U.S. Department
of Transportation
**Federal Highway
Administration**

November 8, 2000

Refer to: HSA-1\HSA-B73

In your letter, you specifically requested acceptance of a Stone Cast Barrier based on the crash performance documented in the Texas Transportation Institute (TTI) May 2000 report, "NCHRP Report 350 TEST 3-11 of the Stone Cast Barrier Wall." The tested barrier installation was 24 meters long and consisted of eight 3-meter long precast units. Each unit is 1100 mm high, including its 300-mm deep x 1200-mm wide footing which is cast integrally with its stem. This stem is 800-mm tall and is nearly vertical, being 600-mm wide at its base and 500-mm wide at its top. The stone veneer on the stem is also cast integrally with each unit. The concrete used had a 28-day compressive strength of 28 MPa and the reinforcing steel met ASTM A615A Grade 400. Enclosure 1 shows these and other details of the design.

Figure 10. Summary of Results for test 400001-SCW1, NCHRP Report 350 test 3-11.

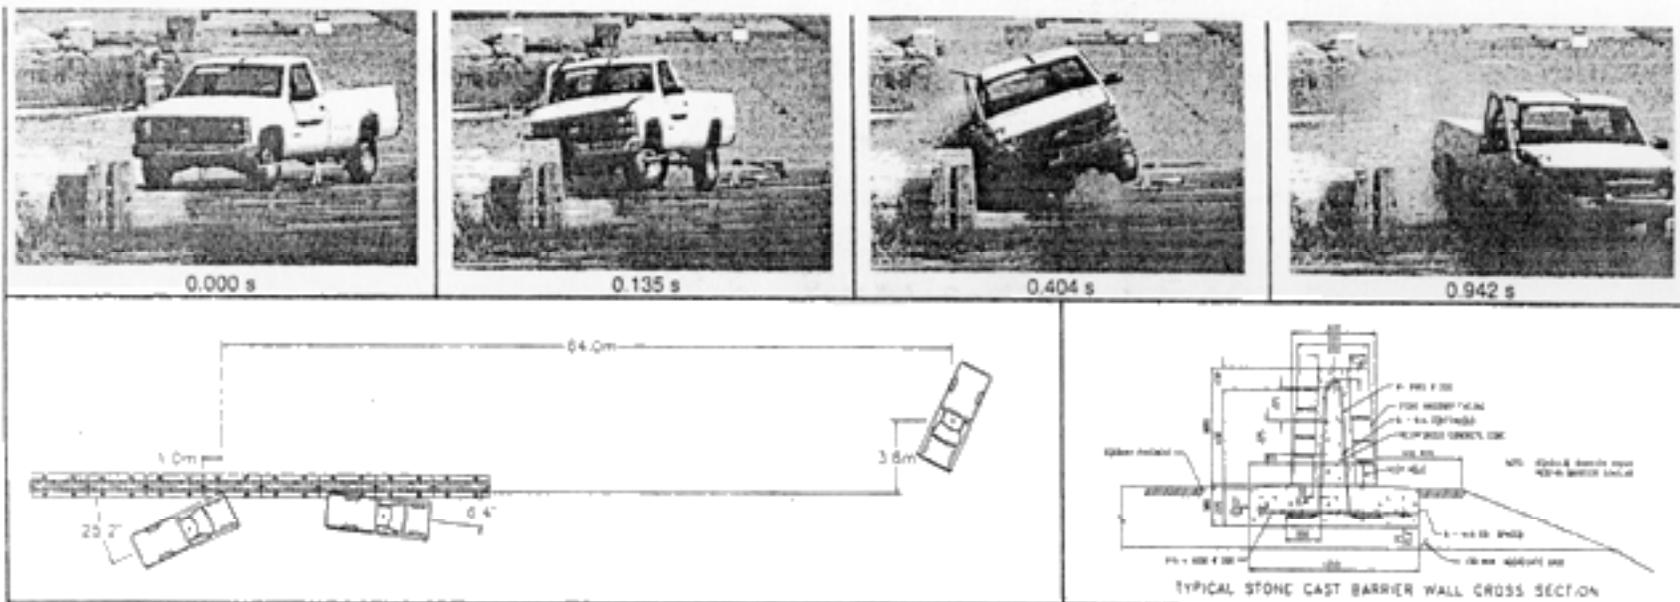
The NCHRP Report 350 test 3-11 was successfully conducted with a 2000-kg pickup truck impacting the test installation at a nominal speed of 100 km/h and an impact angle of 25 degrees. The truck was contained and redirected as desired and occupant severity measurements were well below the maximum values suggested in Report 350. Enclosure 2 shows the summary results of the test. Damage to the test installation was primarily cosmetic, requiring no repairs, and there was no measurable deflection. Based on previous tests successfully conducted on similar barriers with 820-kg cars, we concur with the TTI researchers that Report 350 test 3-10 with the small car is not necessary.

Based on the information presented, we consider the Stone Cast Barrier Wall, as described above, to meet the performance requirements of NCHRP Report 350 at test level 3 (TL-3). It may be used on the NHS when it is selected by the appropriate transportation agency. Since it is a proprietary product, its use on Federally-funded projects, except exempt non-NHS projects is subject to the conditions noted in Title 23, Code of Federal Regulations, Section 635.411, a copy of which is enclosed (Enclosure 3) for your ready reference. Since a crashworthy end terminal has

not been developed for the Stone Cast Barrier, this barrier must be introduced outside the minimum clear zone established for each project by the contracting authority or, preferably, terminated at its full height in a backslope where site conditions permit. Please call Mr. Powers at (202) 366-1320 if you have any questions regarding this acceptance letter.
